SUBJECT: Request to Close a Portion of HIGH DRIVE
MPC File # 10-A-08-SC / City Blocks 42280, 42870 & 42880

TAX MAP
MPC# 10-A-08-SC

Re: Right-of-Way Closure Request 10-A-08-SC

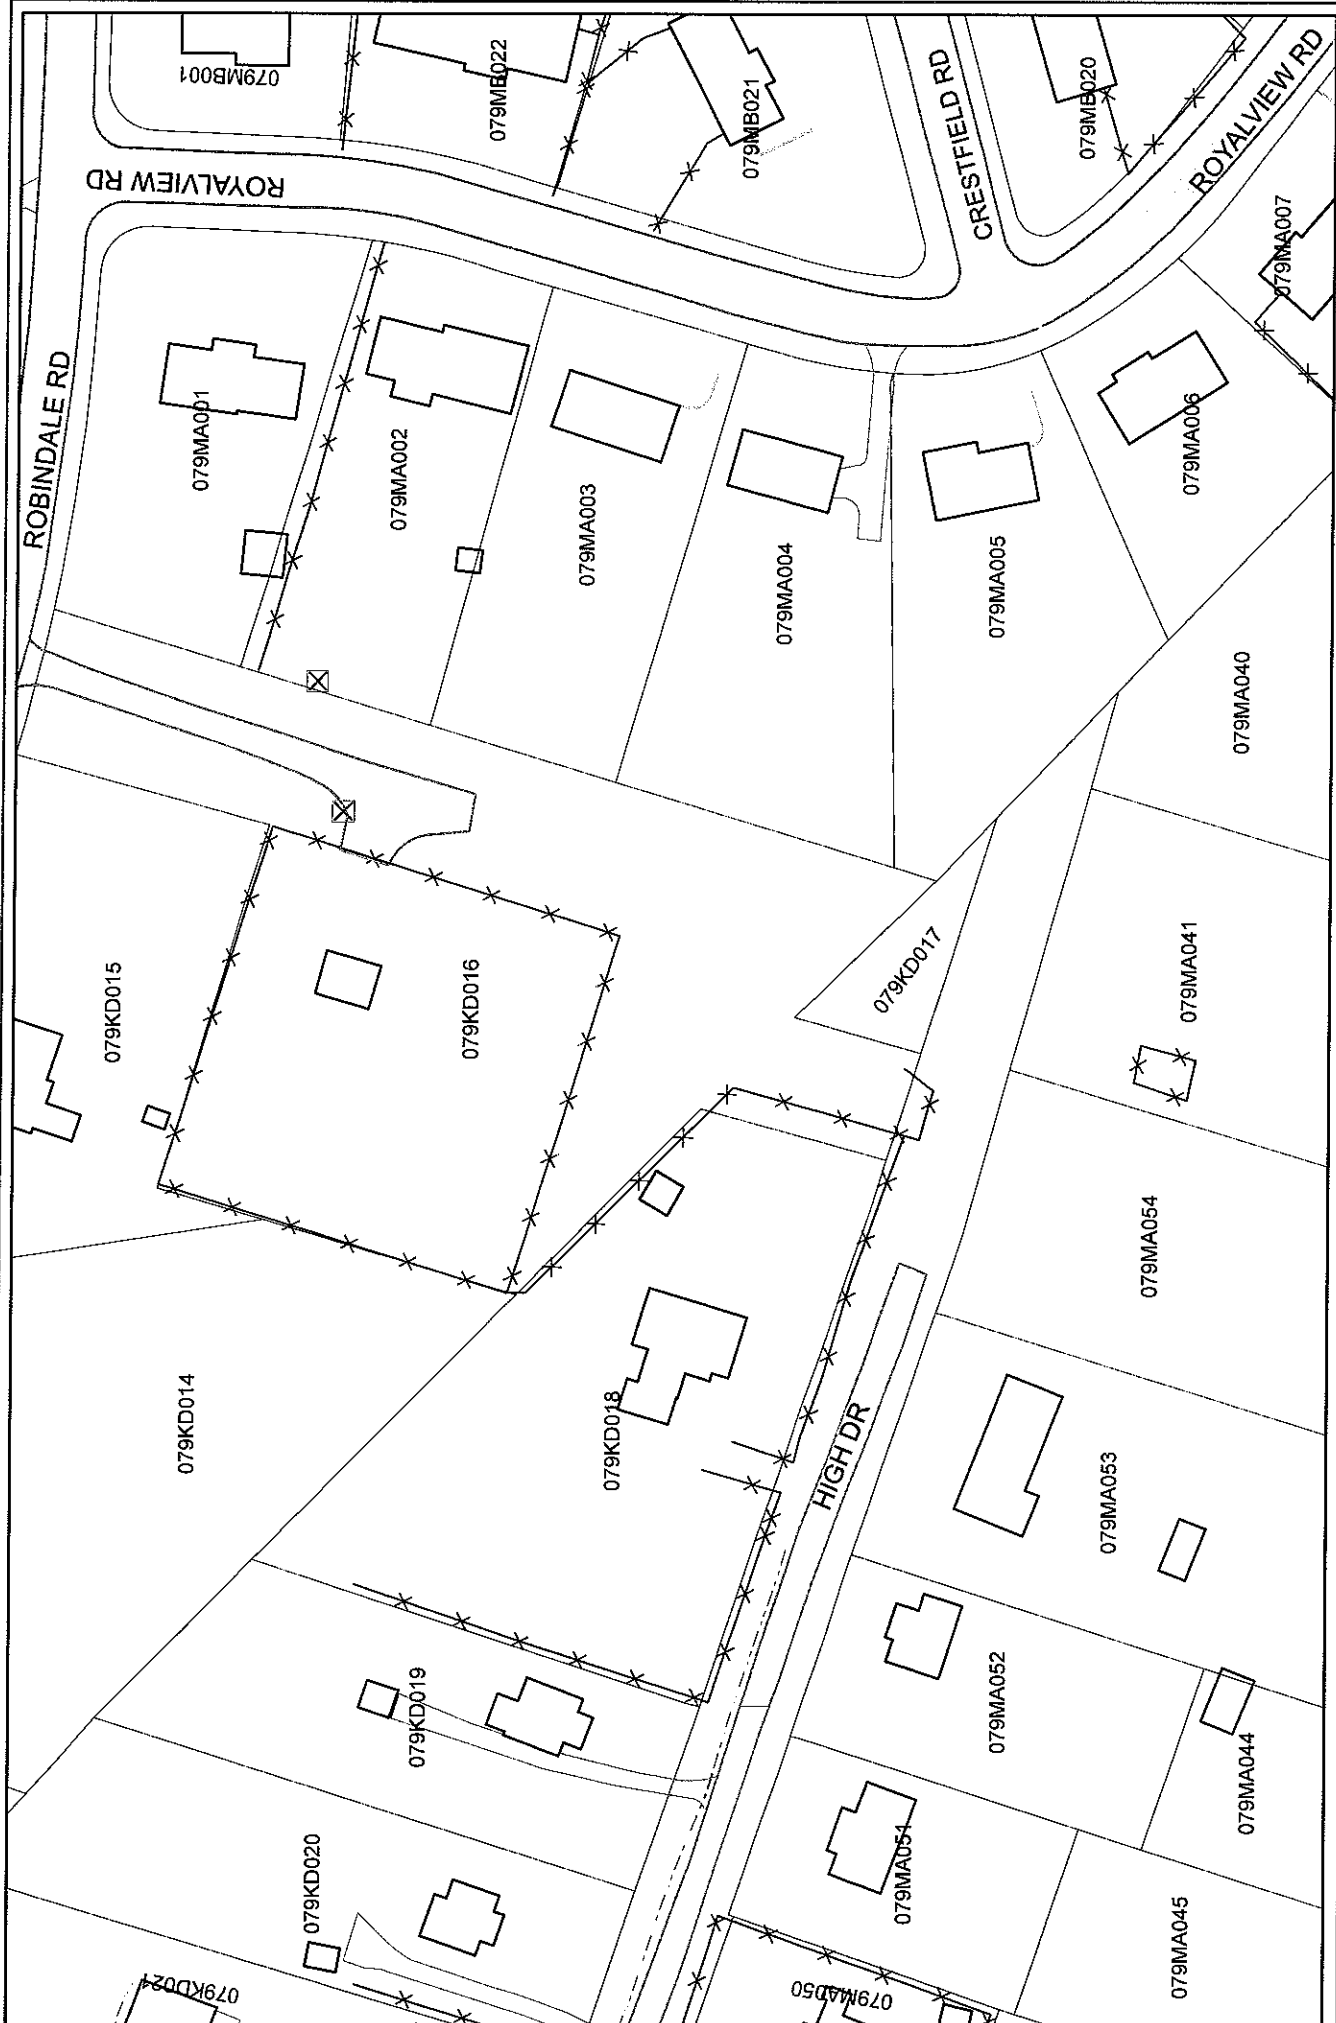
This is a request to close the unopened easternmost end of High Drive. As stated in MPC's *Request for Information* packet, the closure would include an area from the "James F. Leahy Subdivision western boundary to terminus."

The western boundary of the Leahy subdivision appears to be synonymous with the common line between Tax Parcels 079-M-A-052 and 053 shown on the attached tax map. Therefore, the distance to the east terminus of High Drive is approximately 450 feet. If this entire area is closed, Tax Parcels 079-M-A-053, 079-M-A-054, and 079-K-D-017 will become landlocked.

John Patteson of Michael Brady, Inc., has confirmed that the intent of this request is to close only that portion of High Drive that is bounded on the south by Tax Parcels 079-M-A-040 and 079-M-A-041. This distance is only about 200 feet in length.

Therefore, the Engineering Department does not support closing the entire length as currently stated, but does not object to closing the said 200-foot portion that is bounded on the south by Tax Parcels 079-M-A-040 and 079-M-A-041.
